MONTGOMERY COUNTY HISTORIC PRESERVATION COMMISSION
STAFF REPORT

Address:	30 Hesketh Street, Chevy Chase	Meeting Date:	5/22/2024
Resource:	Contributing Resource Chevy Chase Village Historic District	Report Date:	5/15/2024
Applicant:	Kristen Donoghue (Joe Heilman, Agent)	Public Notice:	5/8/2024
Review:	Historic Area Work Permit	Tax Credit:	n/a
Case Number:	1068788	Staff:	Dan Bruechert
Proposal:	Fence Installation

The applicant proposes to install a gate and construct a trash enclosure.

1 PLAN: HVAC/TRASH ENCLOSURE SCREENING
Scale: 1/2" = 1'-0"

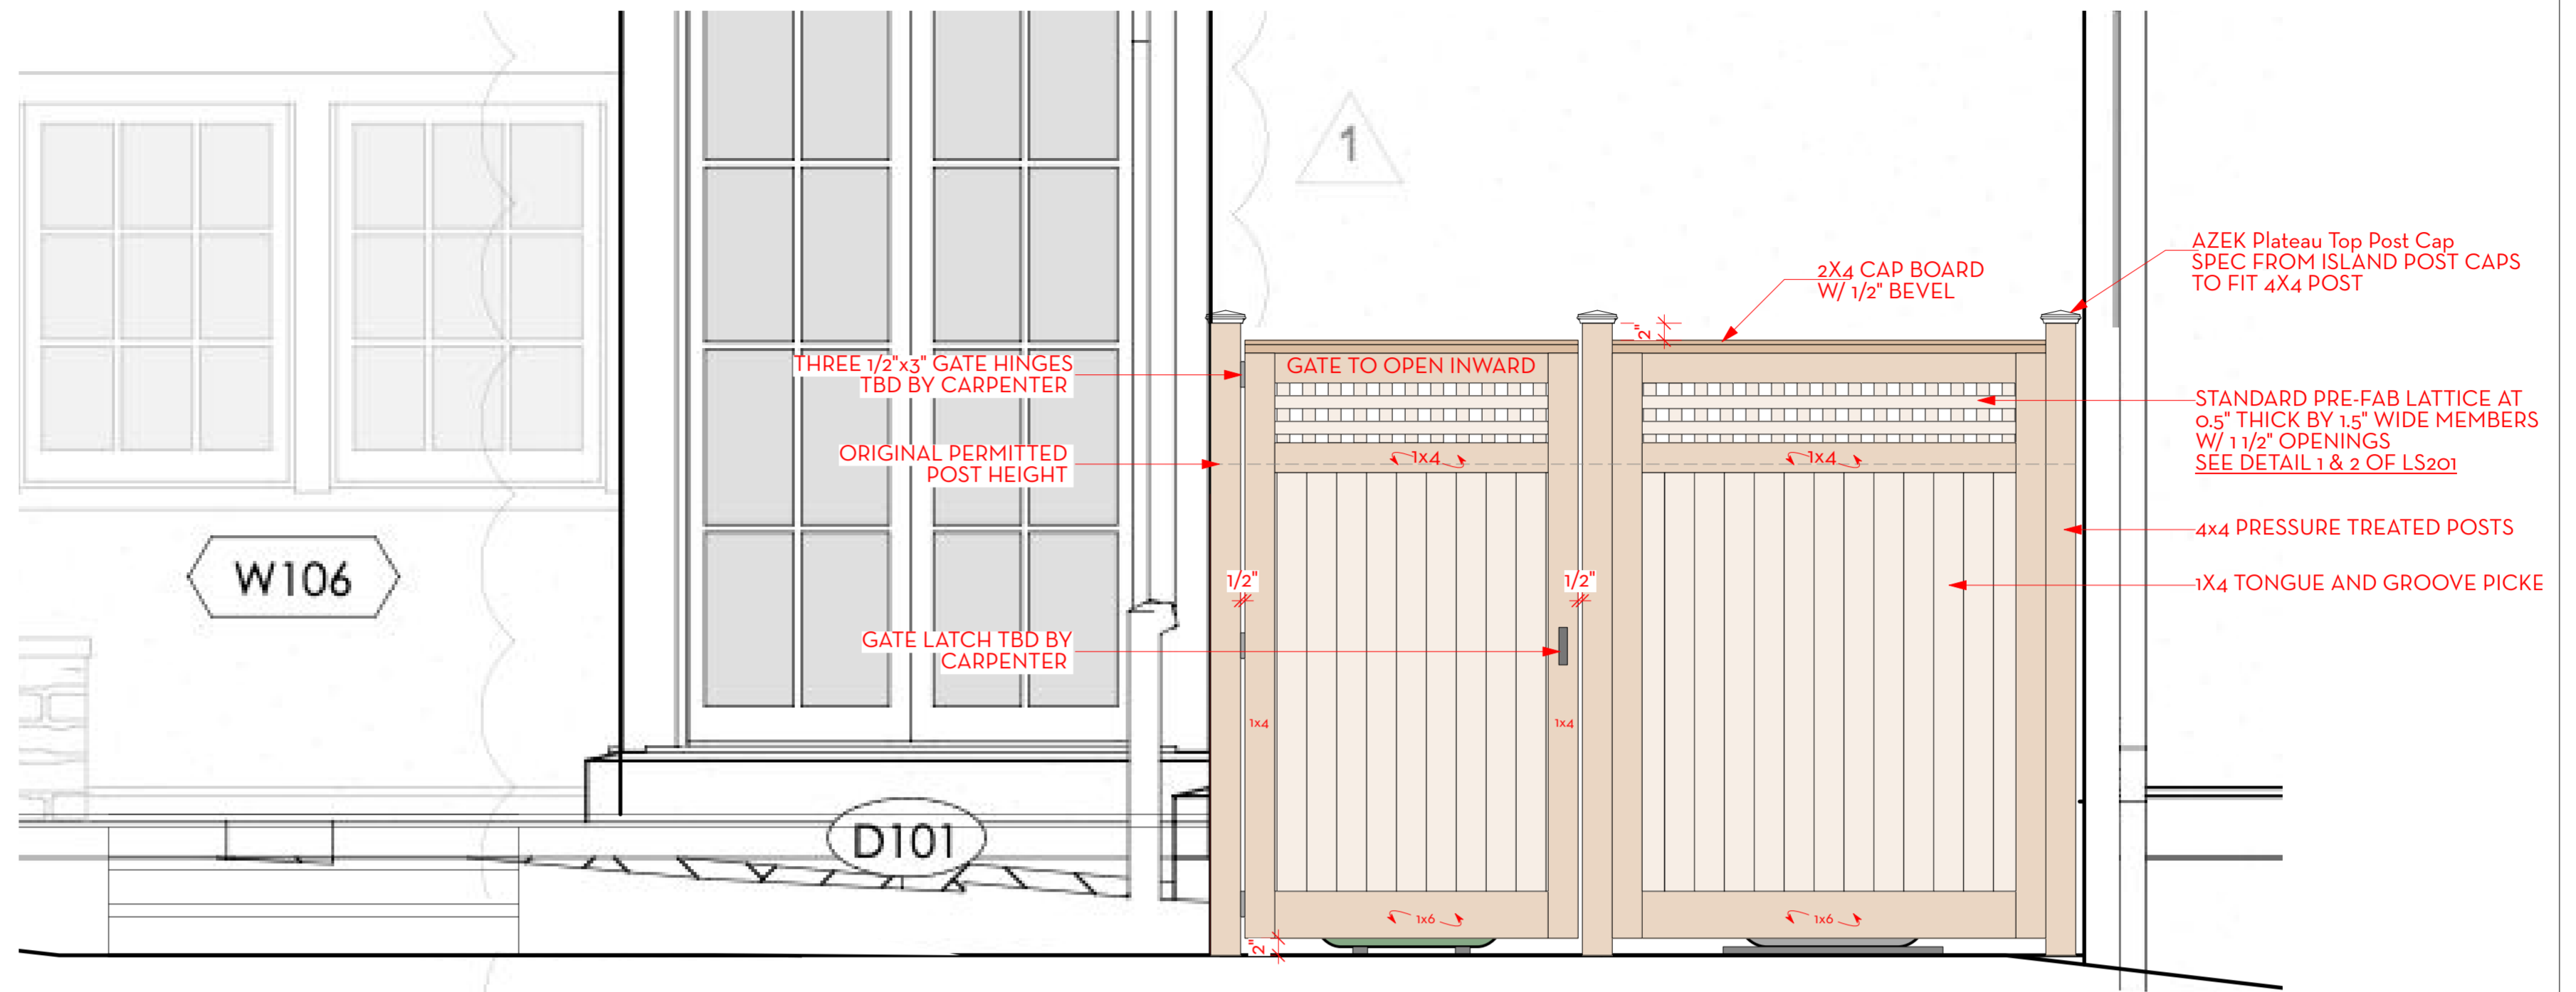
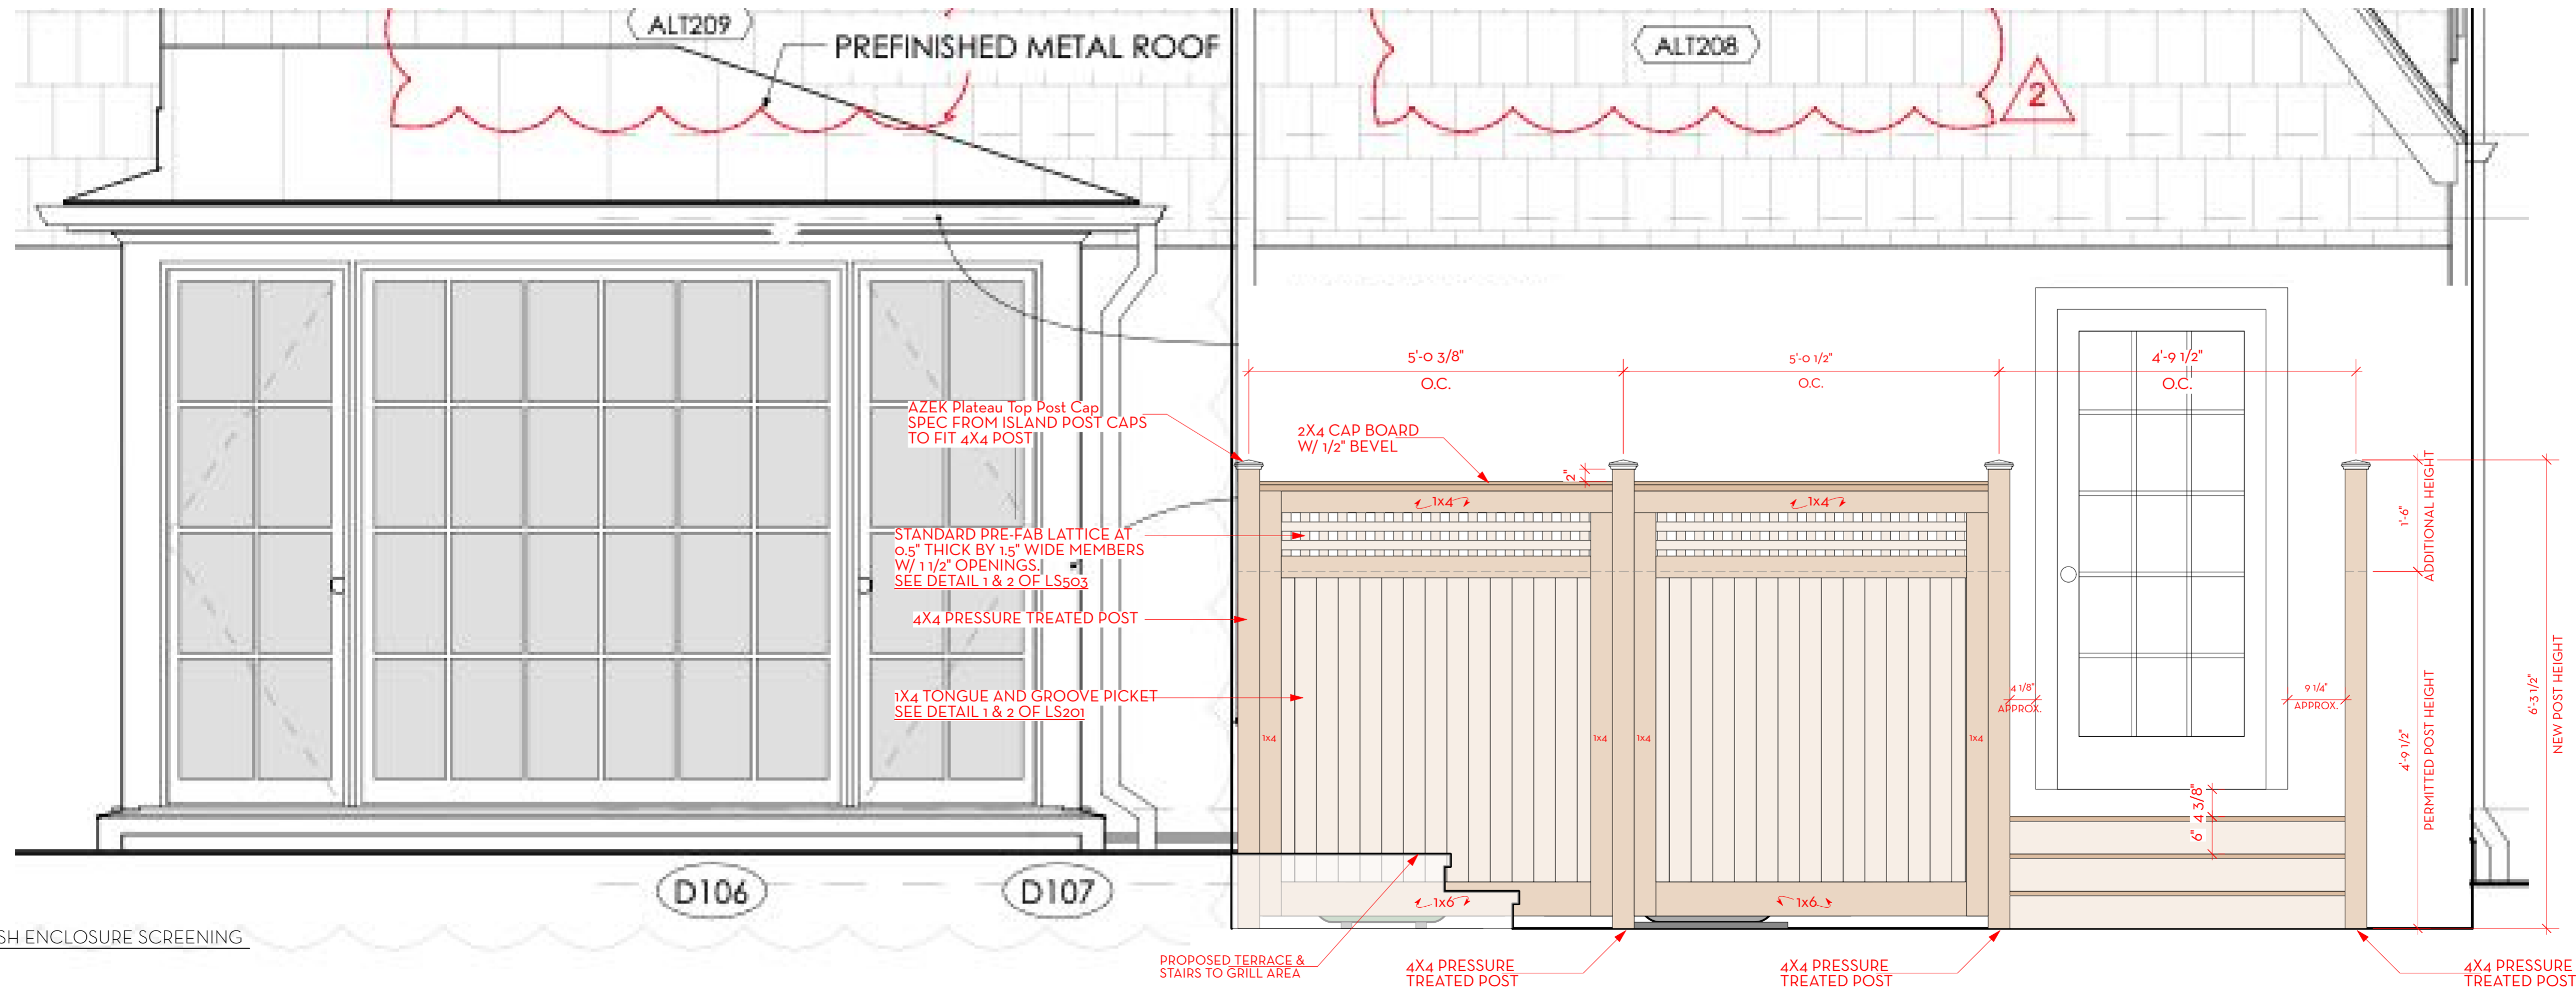
The proposed trash enclosure is a 6' (six foot) tall vertical board enclosure with a lattice topper that measures approximately 10' × 10' (ten feet square) with a gate on the east side. It will be located directly behind the house's non-historic side addition, where it won't be visible from the public right-of-way. Staff finds the proposed design, materials and location are all appropriate under the *Design Guidelines*; Chapter 24A-8(b)(1), (2), and (d); and Standards 2, 9, and 10 and recommends the HPC approve the enclosure.
